BOLTON PLANNING & ZONING COMMISSION
Regular Meeting
7:30 p.m., Wednesday, March 2, 2022
Virtual Meeting
Minutes & Motions

3. Public Hearings (begin at 7:45 p.m.)
a. Special Permit Application for Gas Station/Convenience Store, 271 Hop River Road, Nathan Fleming (#PL-22-2)

Detail Sheet
of
271 Hop River Road
Bolton, Connecticut
Prepared For:
IMS PETROLEUM, LLC
January 3, 2022

SHEET NO. 3 OF 5 JOB NO. 21-000985 DRAWN BY: CAC

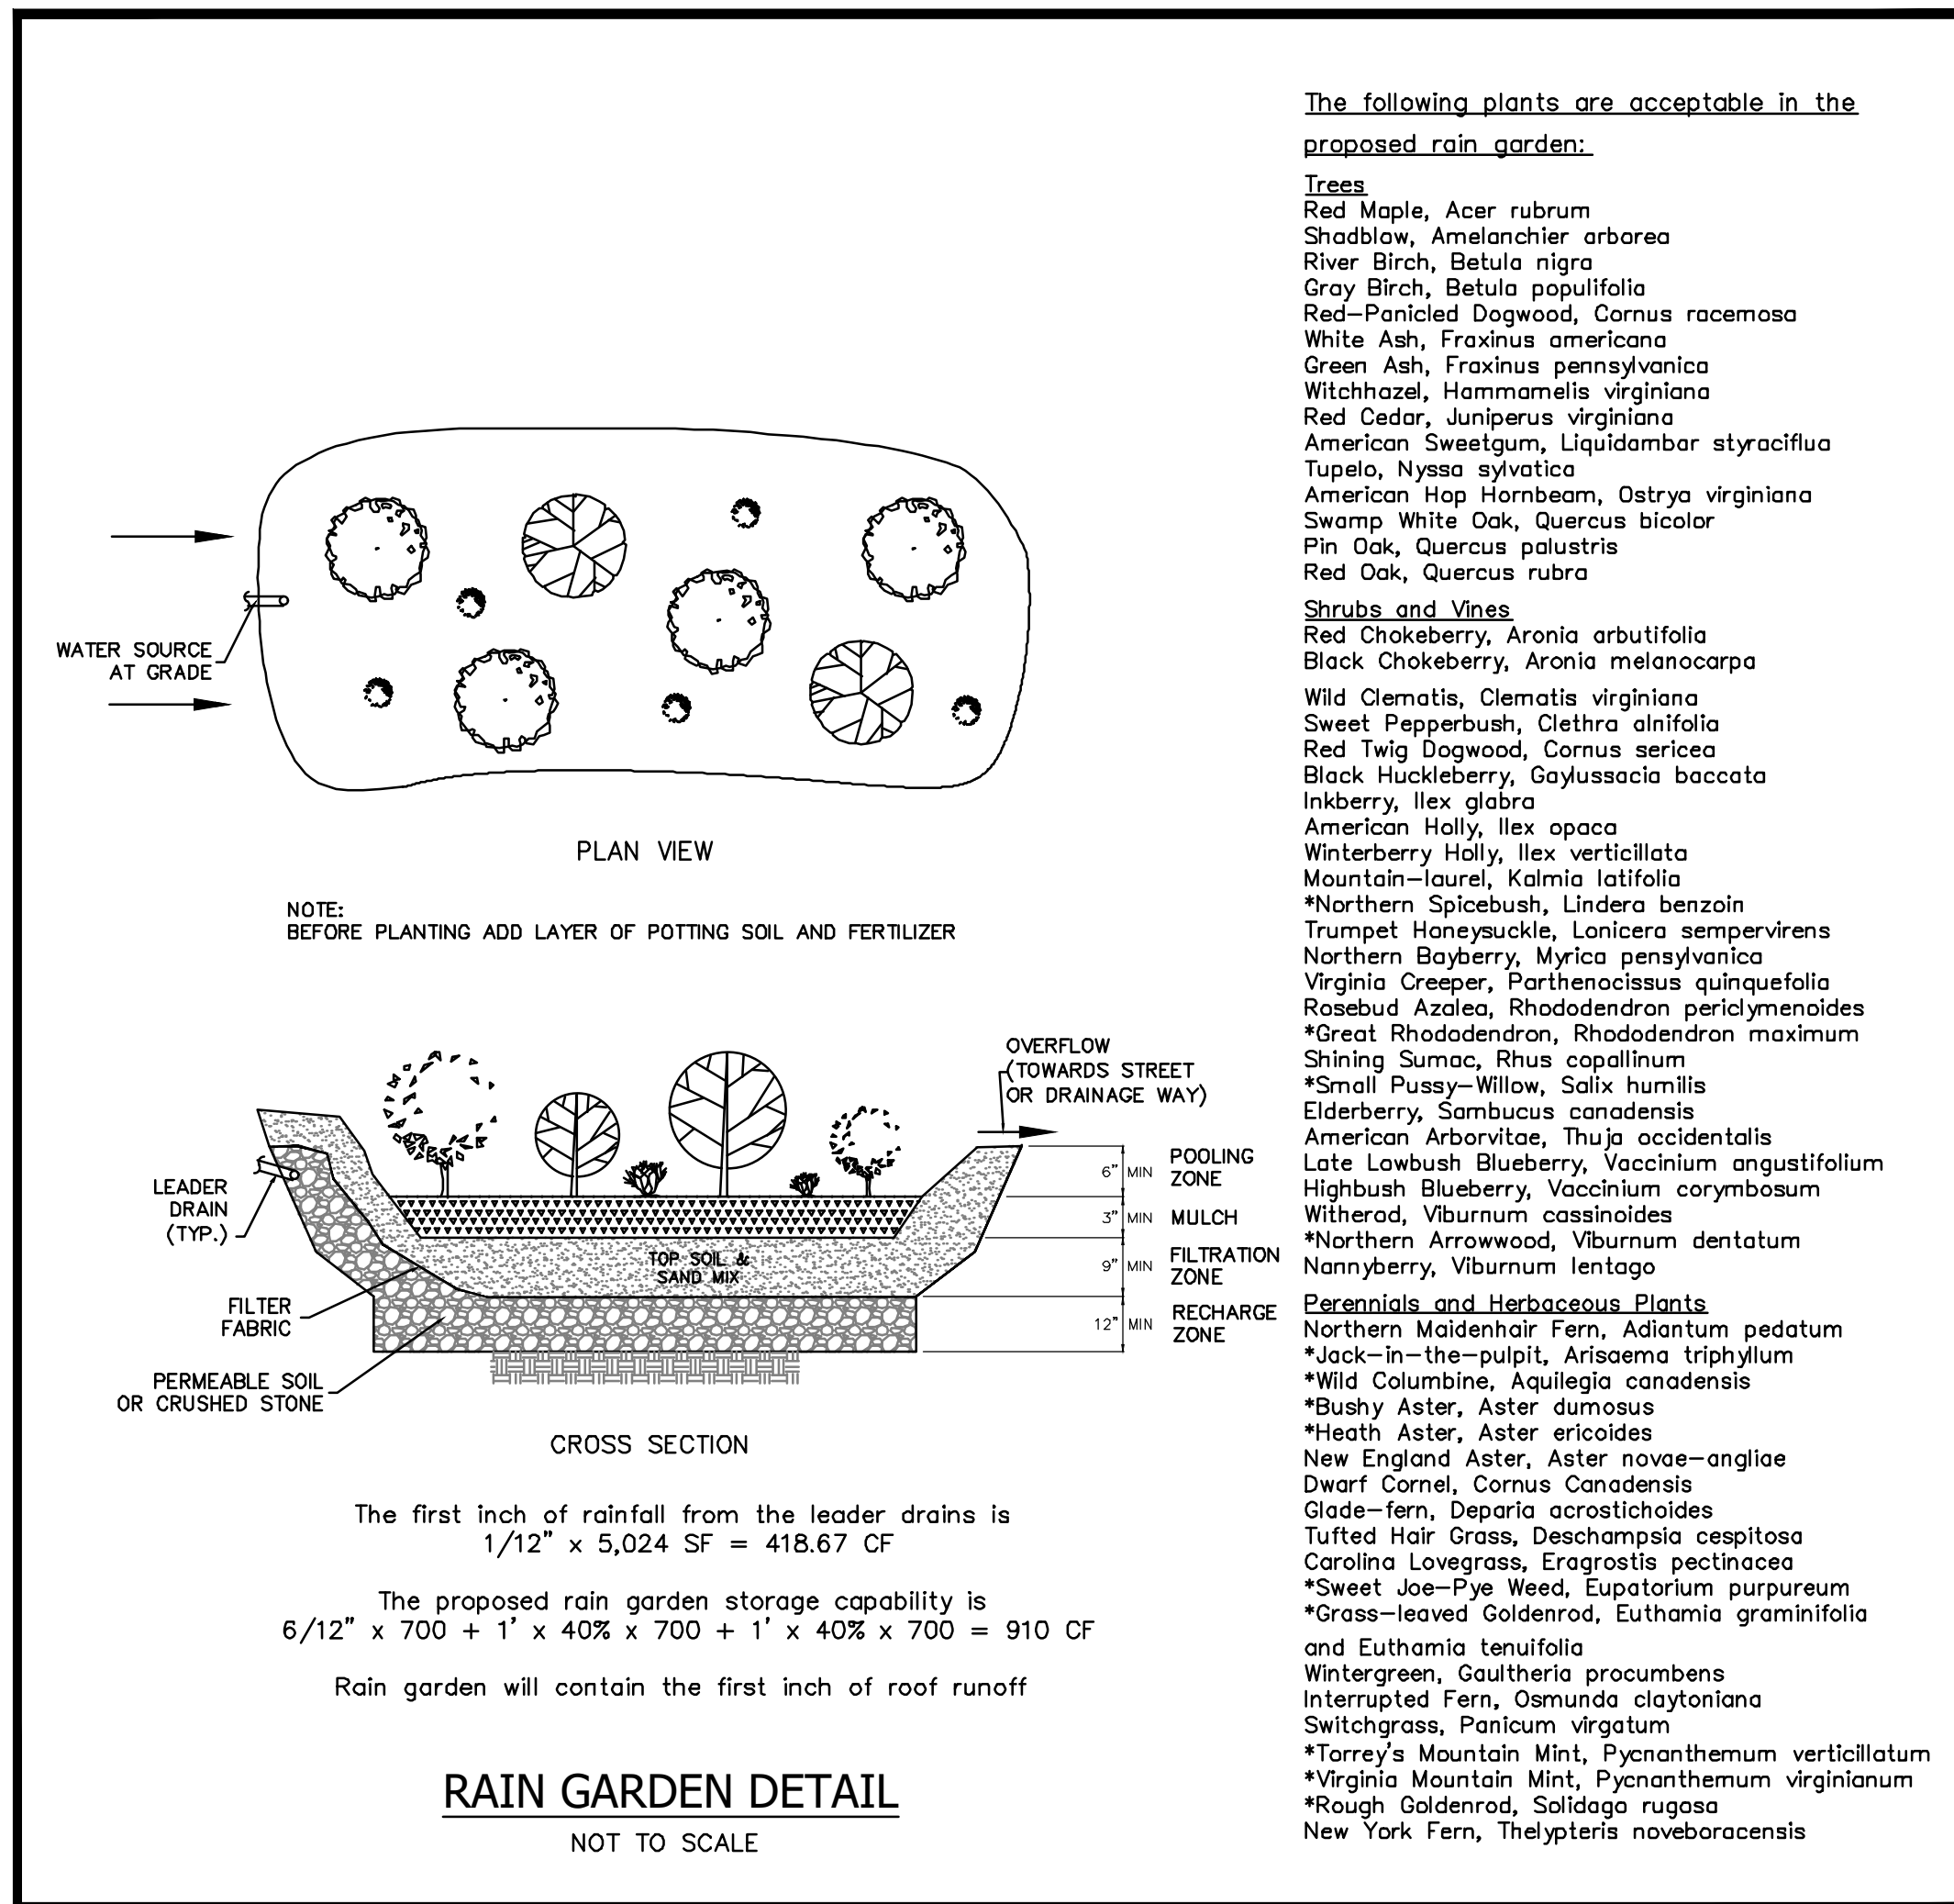
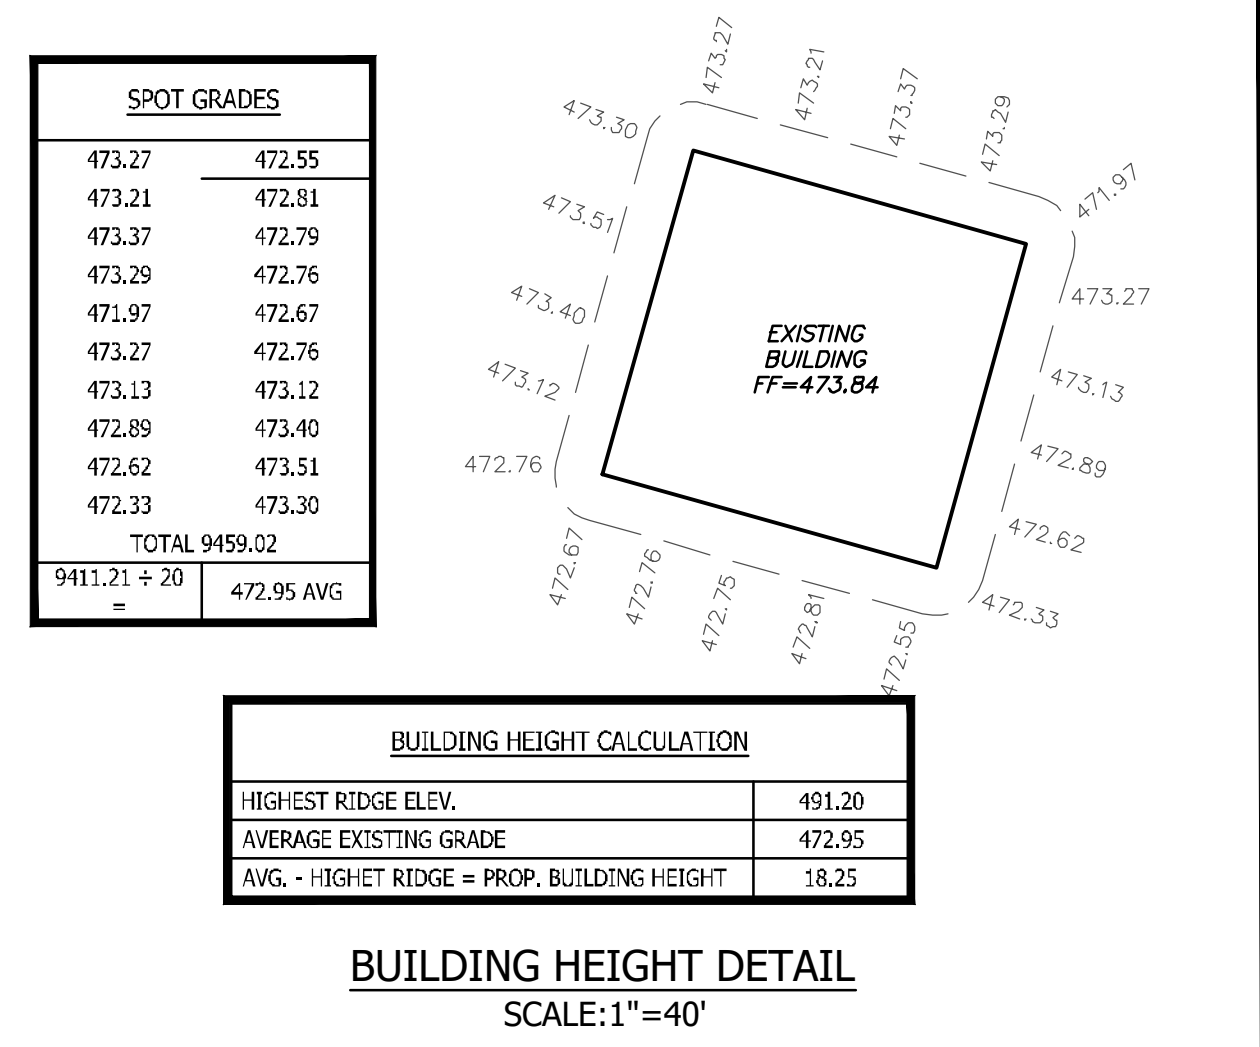
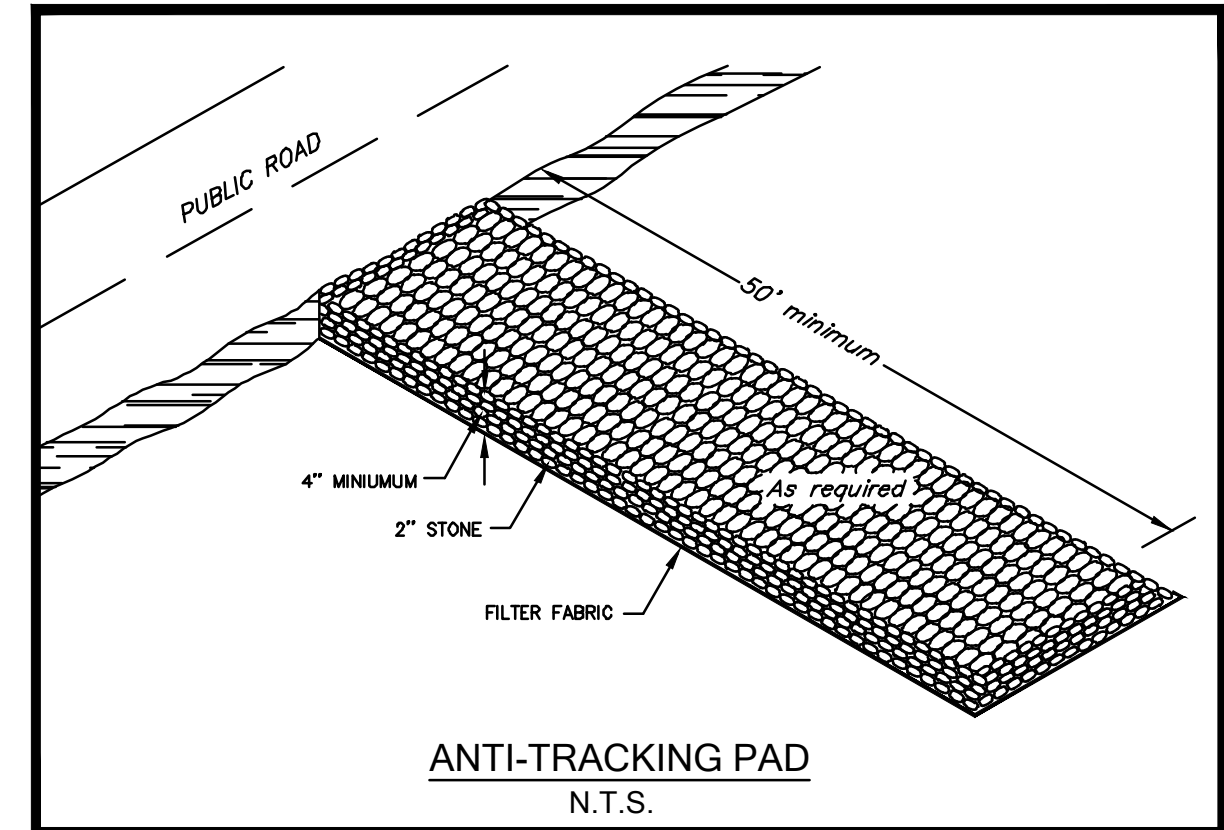
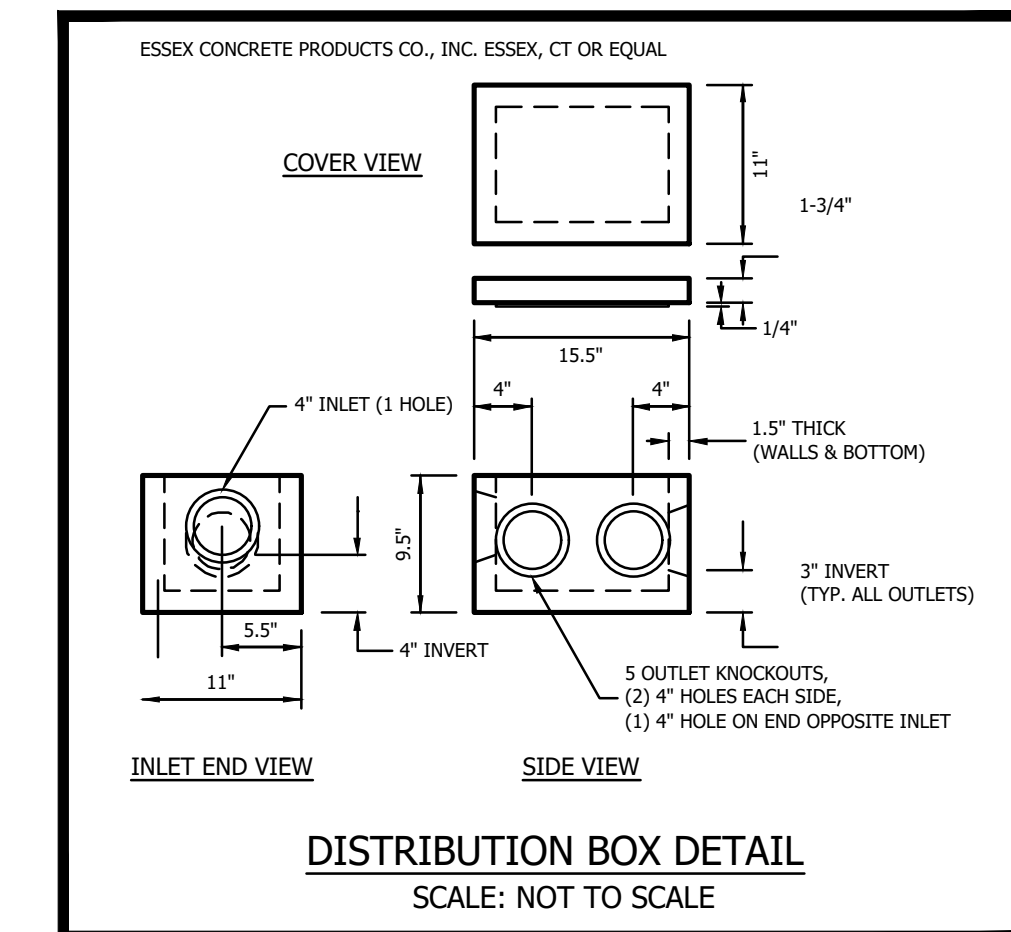
3. A Landscaping Plan in accordance with Section 16A.3.g of the Town of Bolton Zoning Regulations should be provided. – **Landscaping plan added sheet 3 of 5.**

4. A Lighting Plan in accordance with Section 16A.3j of the Town of Bolton Zoning Regulations should be provided. – **Lighting Plan added sheet 3 of 5.**
